1st Review - please contact Rifka Wine with any questions. rwine@bhinc.com

PRELIMINARY DRAINAGE REPORT

ENT CREDIT UNION

E. Hampden Avenue & S. Tower Road
Aurora, CO 80013

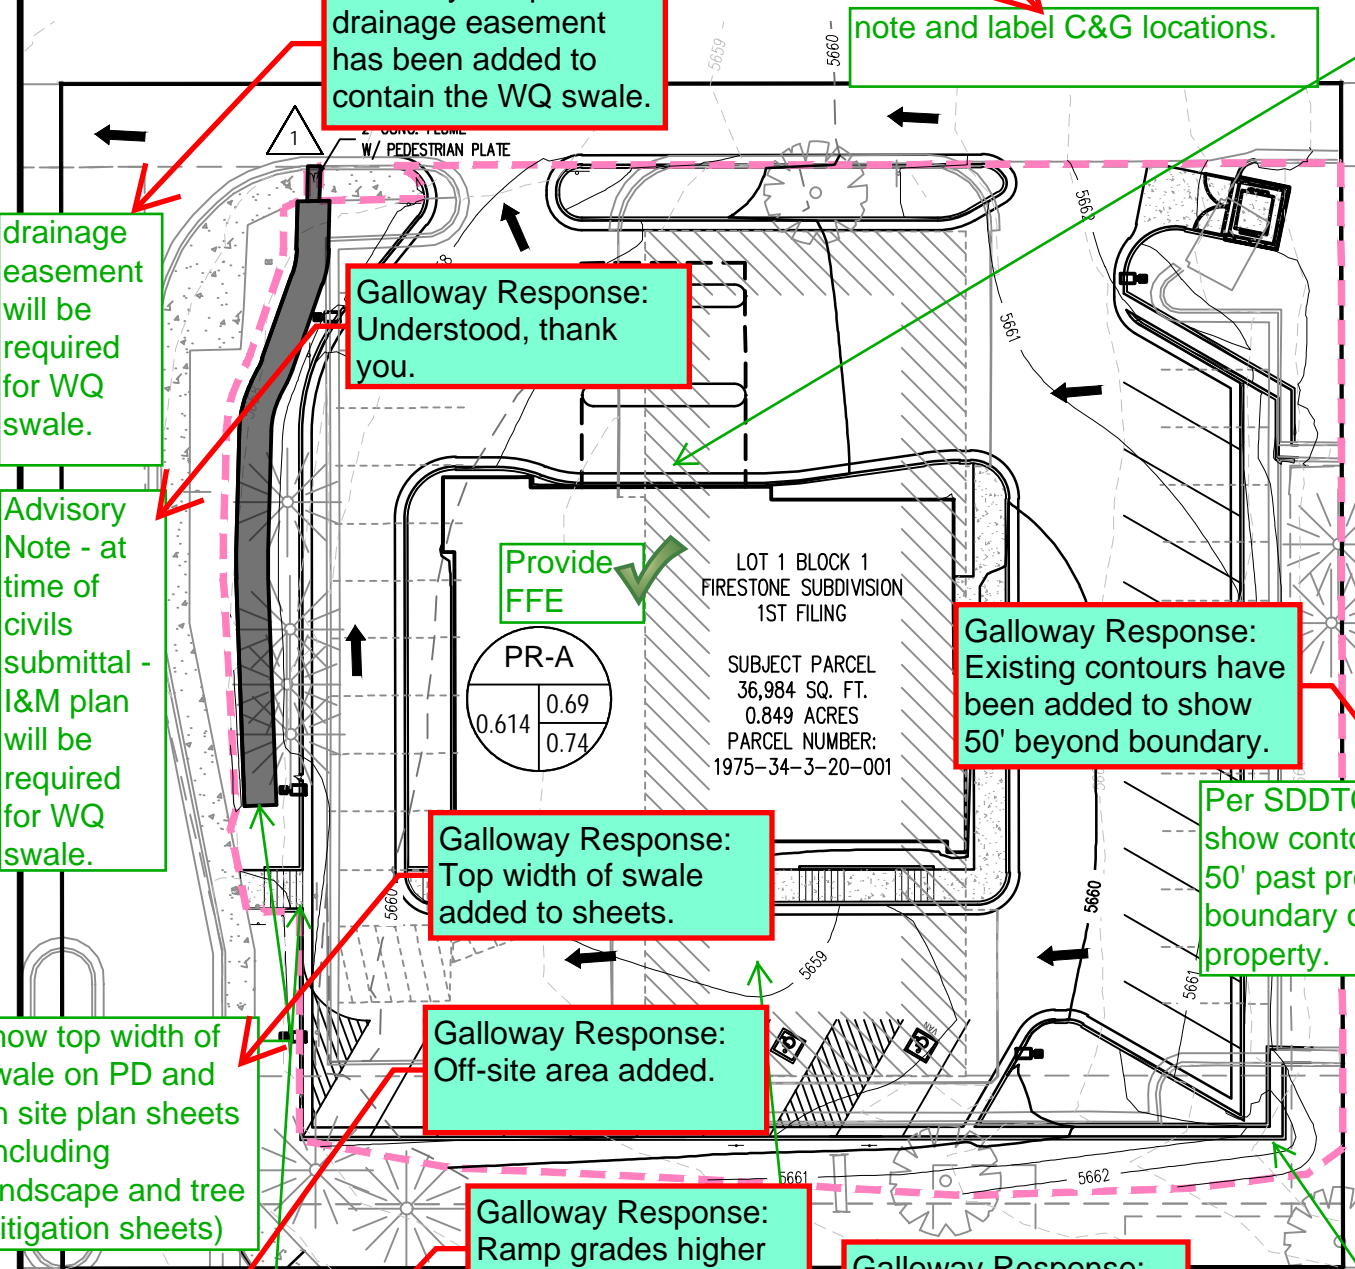
concern with this area being a low point. Must provide positive drainage and no ponding by building allowed. Slope shown for this area in the site plan grading sheet is incorrect based on the contours.

drainage along curb immediately adjacent to the north side of the building. Clearly show slopes away from building. Compare the 100-year flow depth along this curb to the FFE, must provide a min. of 1' of freeboard. Account for the off site flow from the northern run down that will flow toward this area.

Per SDDTC Sect 2.34, show contours a min. of 50' past property boundary on all sides of property.

COA Benchmark must be shown & referenced. Include elevation & NAVD 1988 reference.

Required plan items missing (see SDDTC Sect 2.34 for more information):
1. Existing and proposed easements (drainage, utility, fire, etc). Show dimensions of each, with dimension arrows.
2. indicate public or private maintenance of all storm infrastructure (swales, etc.).
3. indicate design storm frequency required to be shown for swale.
4. COA benchmark missing, include COA ID, elevation & NAVD 1988 datum reference.

Show all slopes (slope requirements in the COA Roadway Design and Construction Specifications Manual). Minimum 0.50% slope on all concrete surfaces, minimum 1% slope on all asphalt surfaces, minimum 2% slope on all grass-lined swales and landscape areas. The slope away from the buildings shall have a minimum grade of 5% for the first 10' or to the property line for landscape areas, whichever occurs first, then a minimum of 2% until the slope reaches the swale around the building. Impervious surfaces within 10' of the building foundation shall be sloped a minimum of 2% away from the building.

Galloway Response: Grades slope away from building. Additional slope labels have been added for clarification. Spill curbs so no flow within gutter

Galloway Response: Existing contours have been added to show 50' beyond boundary.

Galloway Response: 1. Existing/Proposed Esmts added
2. Maintenance responsibility indicated.
3. Design storm frequency indicated.
4. COA benchmark added

Galloway Response: Slope labels have been added to show slope compliance
